# ADDENDUM

Application Number:	AWDM/0970/23 & AWDM/0163/24	Recommendation - Approve	
Site:	42 Brighton Road, Lancing		
Proposal:	<ul> <li>construction of a over 3 levels with works. New outbui south. New detach over and cycle store approved AWDM/08 in height of house balconies to front. Increase 0.37m; addition of construction dwelling over 3 associated works. terrace to the sour guest bedroom over Application to Vary previously approve</li> </ul>	<ol> <li>AWDM/0970/23Demolition of existing dwelling and construction of a 4-bedroom detached dwelling over 3 levels with rear terrace and associated works. New outbuilding with raised terrace to the south. New detached garage with guest bedroom over and cycle store to the north. Application to Vary Condition 1 (approved plans) of previously approved AWDM/0923/21. Amendments: Increase in height of house by 0.85m, addition of first floor balconies to front elevation, addition of lightwells to front. Increase in height to garage block by 0.37m; addition of cladding to garden room</li> <li>AWDM/0163/24 - Demolition of existing dwelling and construction of a 4-bedroom detached dwelling over 3 levels with rear terrace and associated works. Ne

*Images showing ground level of No. 44 to the left, and the raised ground level of No. 42 to the right.*

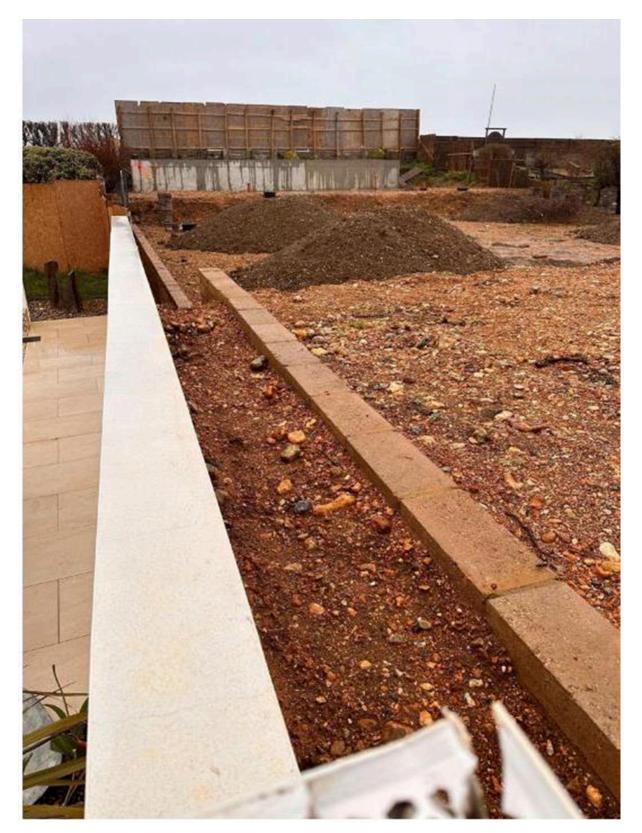
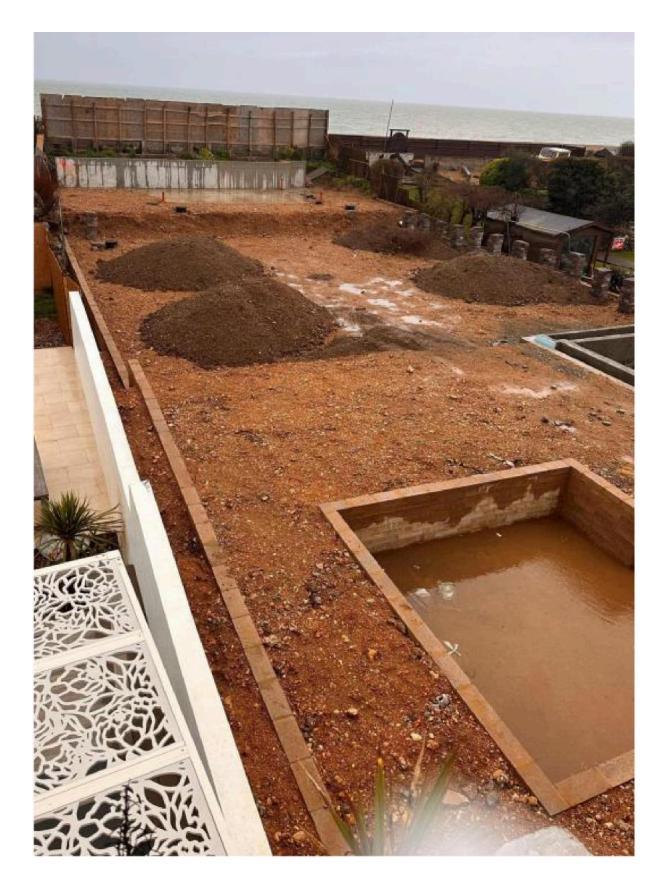
Due to the unlawful alterations made to the ground levels of the proposal site, the rear garden of the application site sits significantly higher than that of No. 44. The proposal seeks to limit the impact of the significantly raised ground levels by the slight set back of the wall from the site's boundary, and the imposition of a hedge between the wall and No. 44. However, this would still result in a significantly tall boundary feature, sitting significantly above the existing boundary wall of No. 44 (extending around 12ft above the garden level of this dwelling), resulting in significant residential amenity impacts through overbearingness and overshadowing. The images below show the new, raised ground level of No. 42, in comparison to the top of the boundary wall of No. 44; it is clear that the provision of another boundary at the new, raised ground level would result in significant overbearing and loss of light impacts to the residents of No. 44.

It is considered that the garden heights should be revisited in line with Condition 10 of the original application, which would allow the residential amenity of the occupiers of No. 44 to be retained, without any excessive overlooking or exceedingly tall boundary features directly next to their living areas.

It is considered that the significant residential amenity impacts from the current application would remain, and as such, the proposed alterations would not comply with Policy 15 of the Adur Local Plan 2017 or Paragraph 127 of the NPPF and as such, should be refused.
